Subject: License Renewal
UFSAR Supplement, March 2000
Oconee Nuclear Station
Docket Nos. 50-269, -270, -287

Oconee Nuclear Station

UFSAR Supplement

March 2000

Appendix 16.6-2
Figure 1
Units 1, 2, and 3

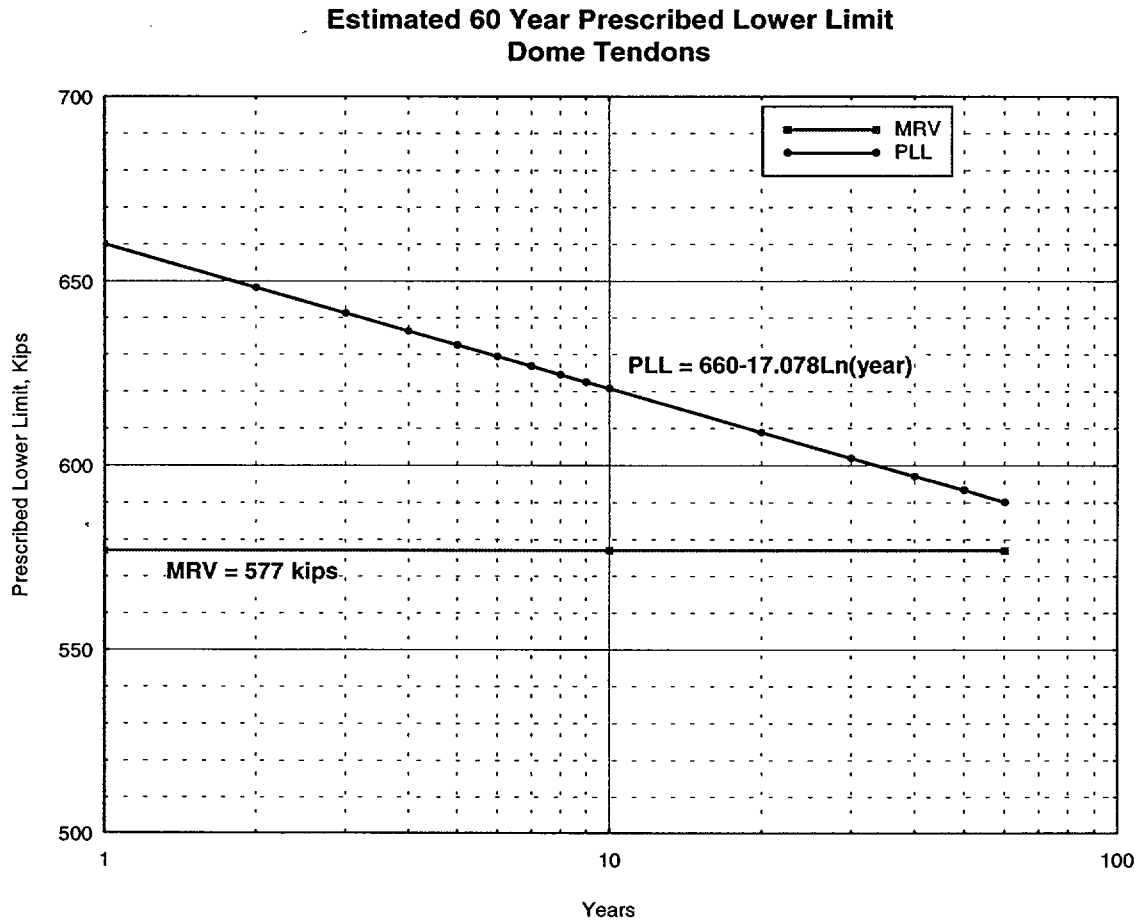
Revise Figures 1, 2, and 3 of SLC 16.6.2 as follows:
